**STATE OF NEW MEXICO  
BEFORE THE WATER QUALITY CONTROL COMMISSION**

**PETITION TO AMEND 20.6.4.126 NMAC AND  
20.6.4.141 NMAC TO ESTABLISH A SEGMENT-  
SPECIFIC TEMPERATURE CRITERION  
FOR A PORTION OF THE UPPER SANDIA  
CANYON ASSESSMENT UNIT**

**WQCC No. 24-65**

**PETITION FOR RULEMAKING TO AMEND 20.6.4.126 AND 20.6.4.141 NMAC  
TO ESTABLISH A SEGMENT-SPECIFIC TEMPERATURE CRITERION  
FOR A PORTION OF THE UPPER SANDIA CANYON ASSESSMENT UNIT**

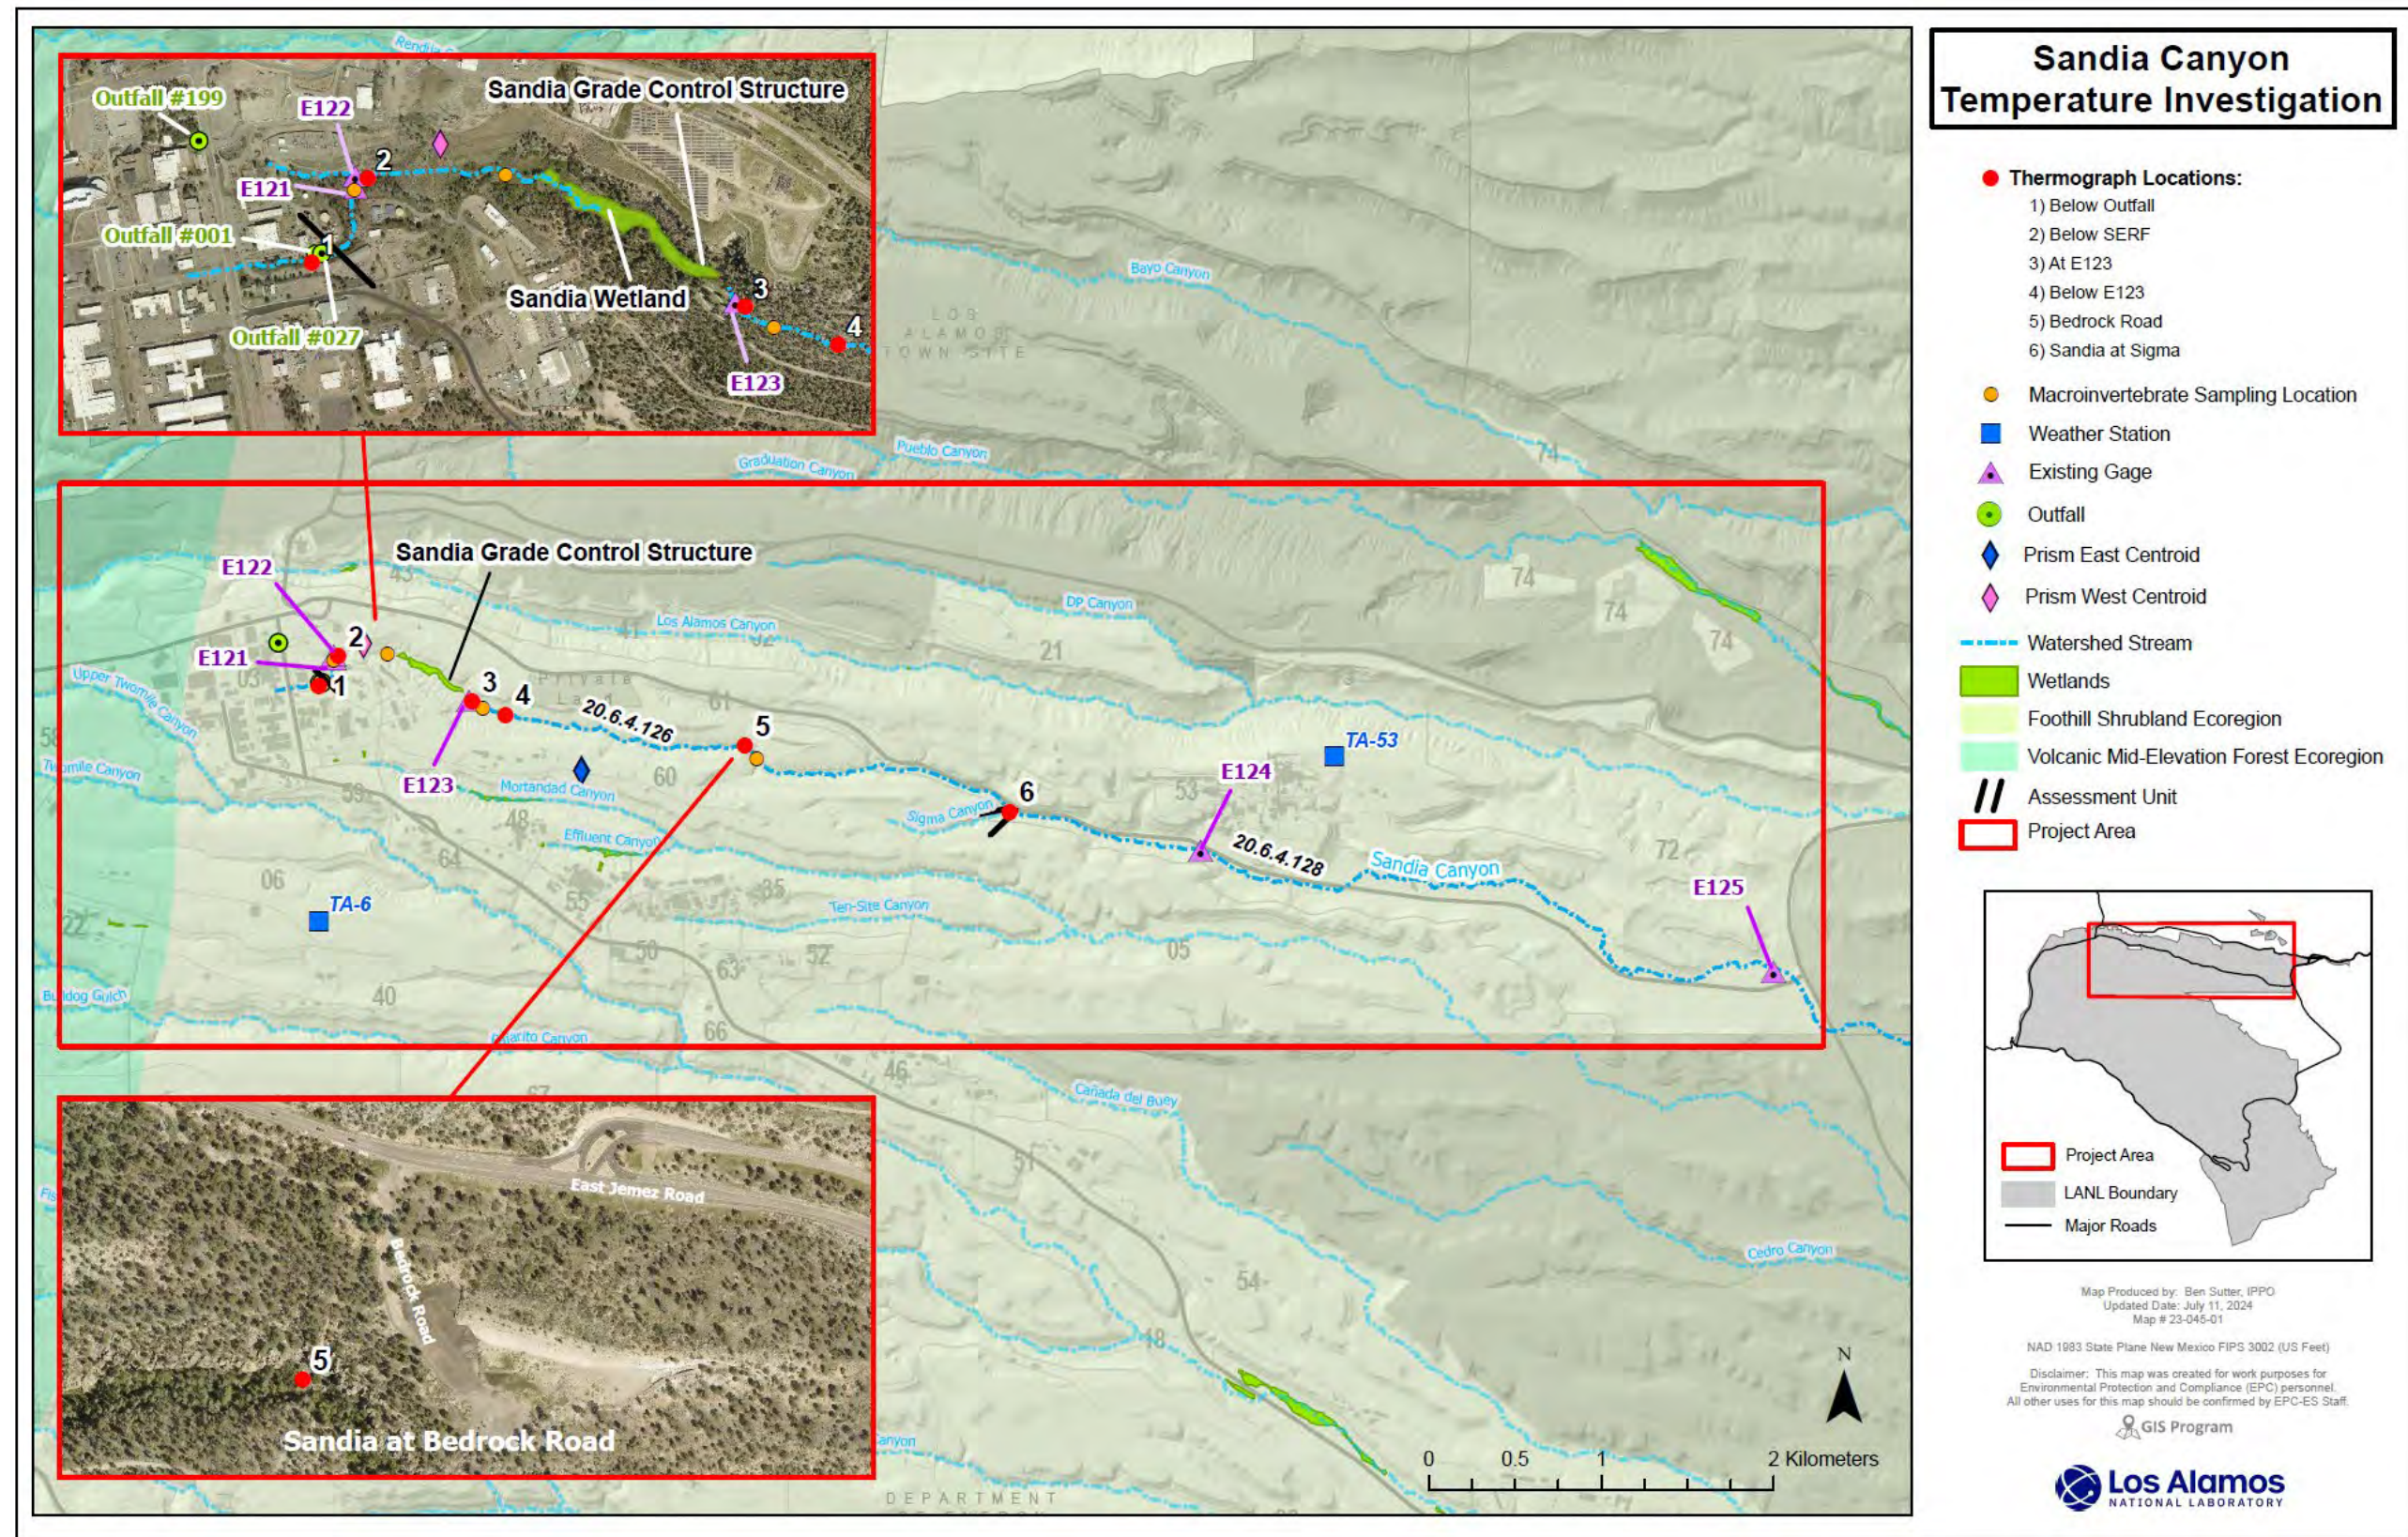
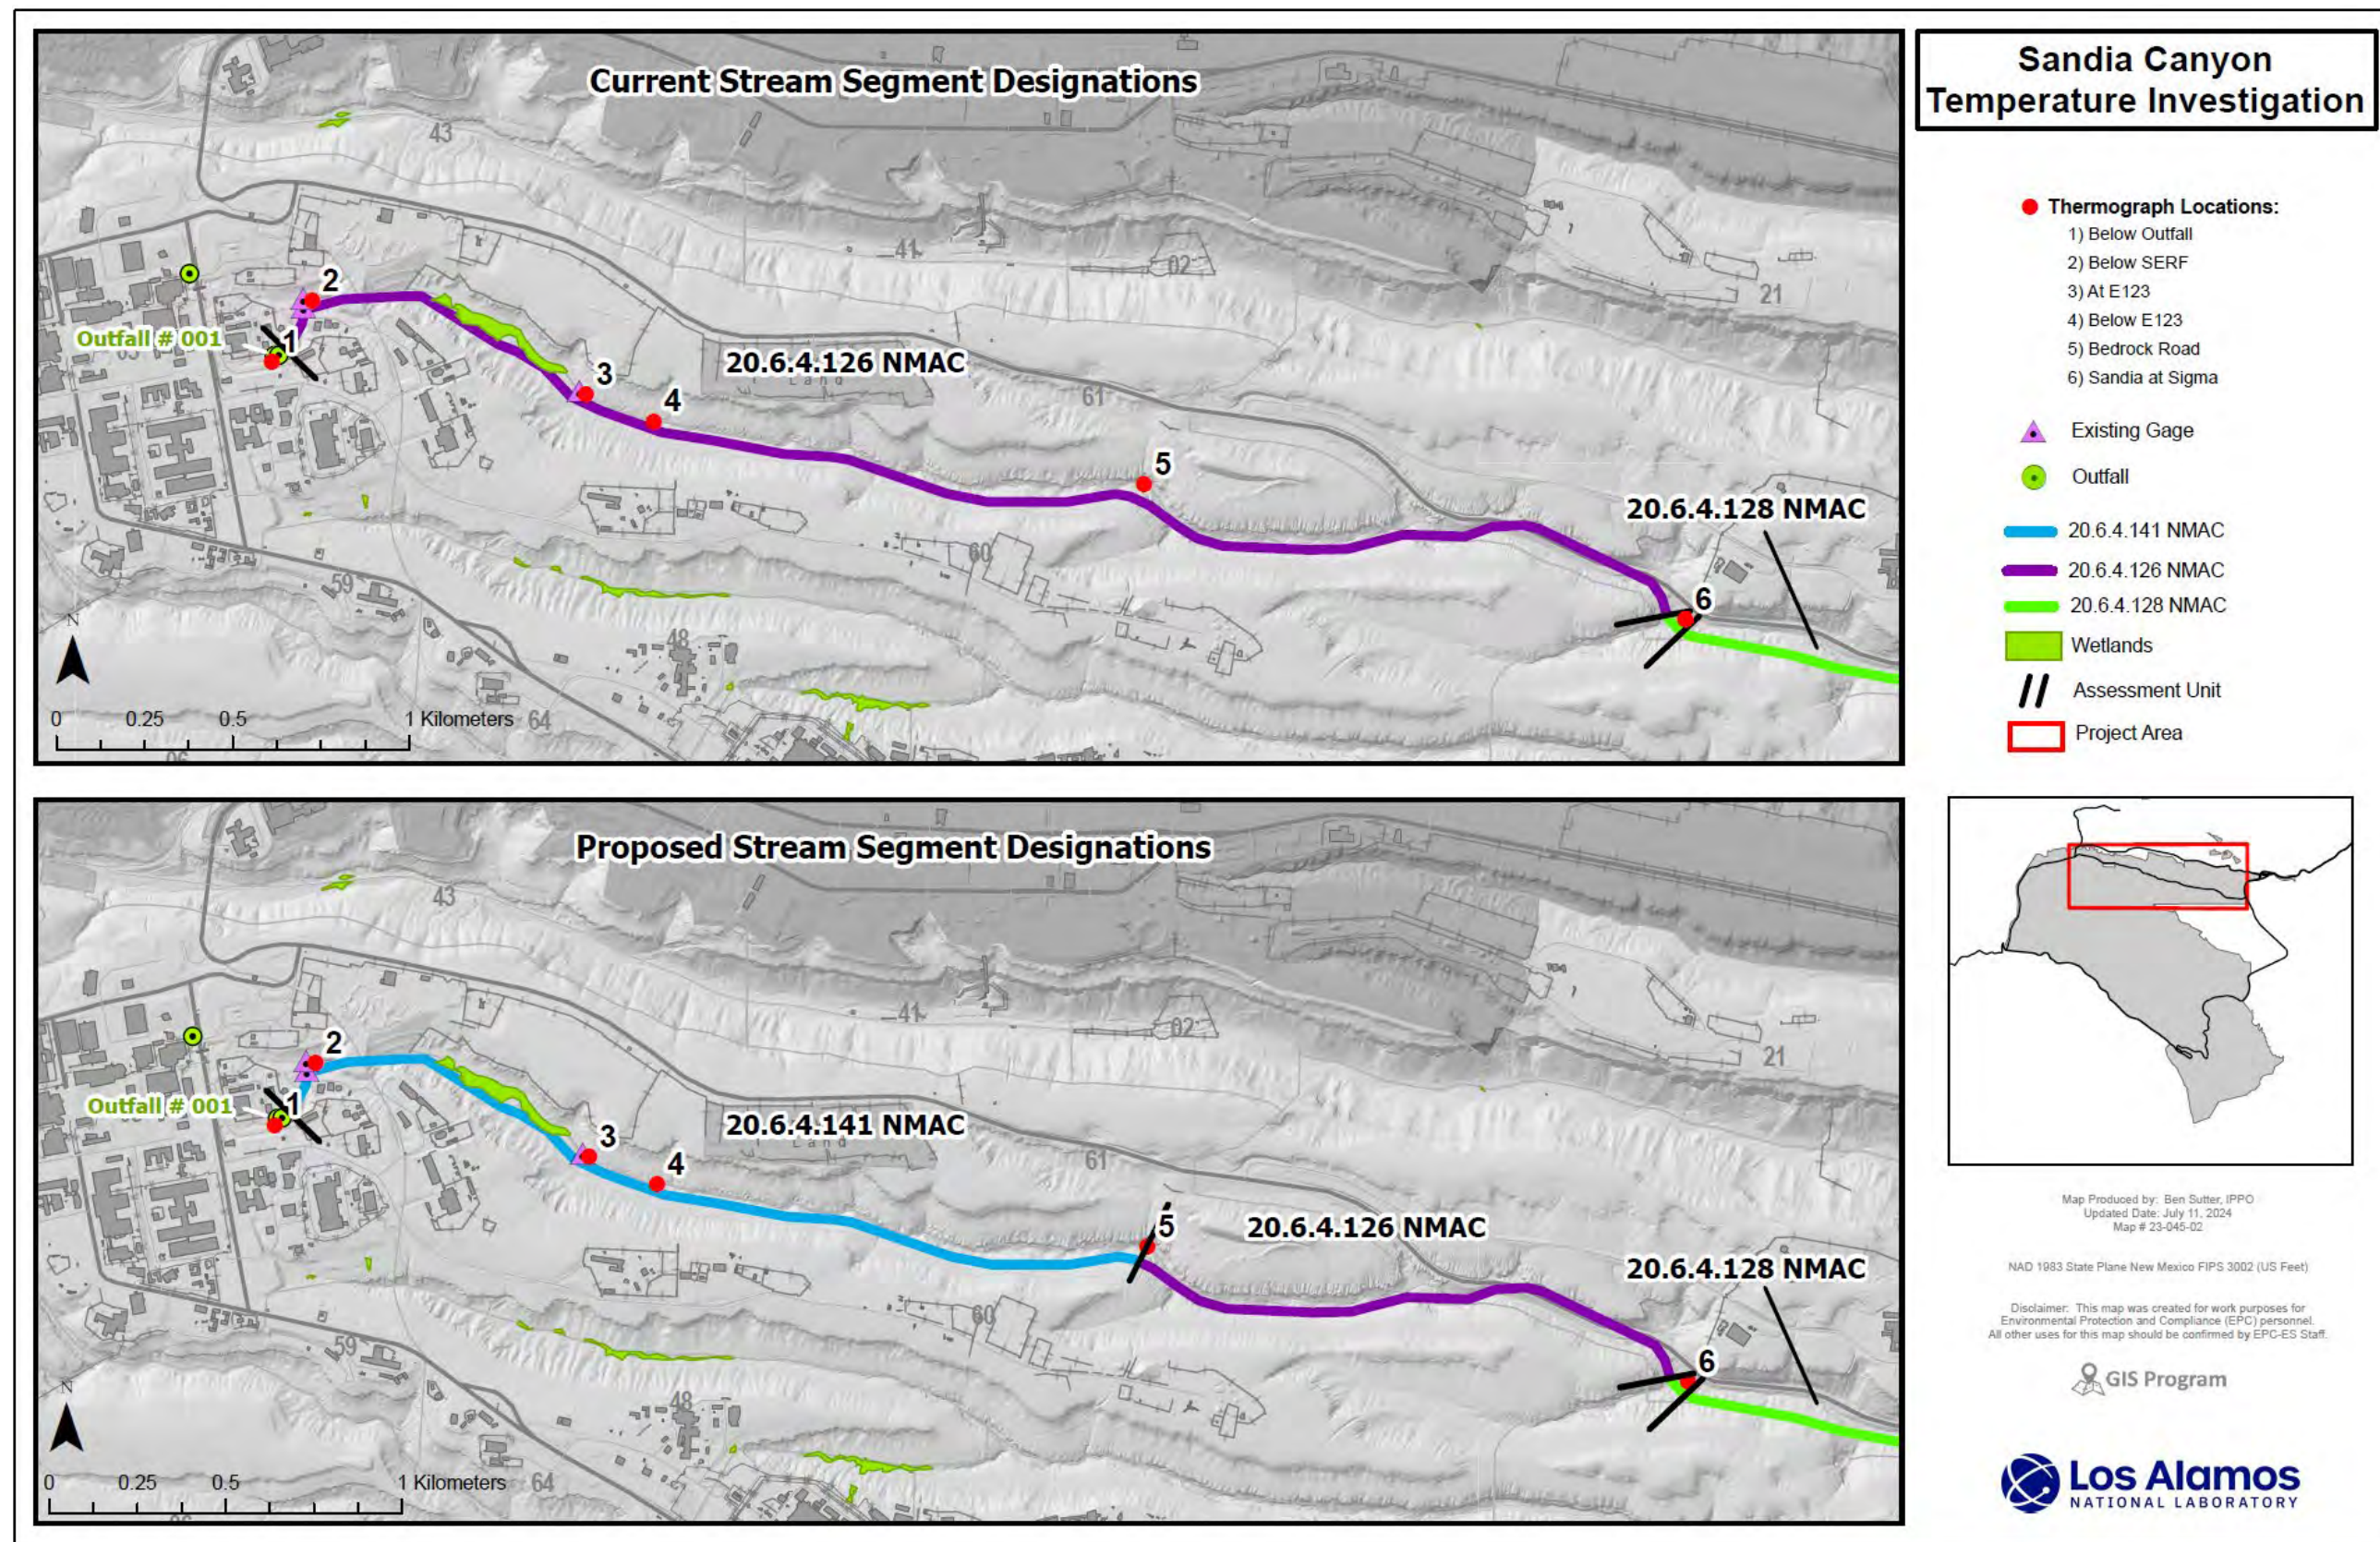
- 2) Figure 1, p. 4 (Attached) – updated to include scale, north arrow, and clarify labeling
- 3) Figure 2, p. 5 (Attached) – updated to include scale, north arrow, and clarify labeling
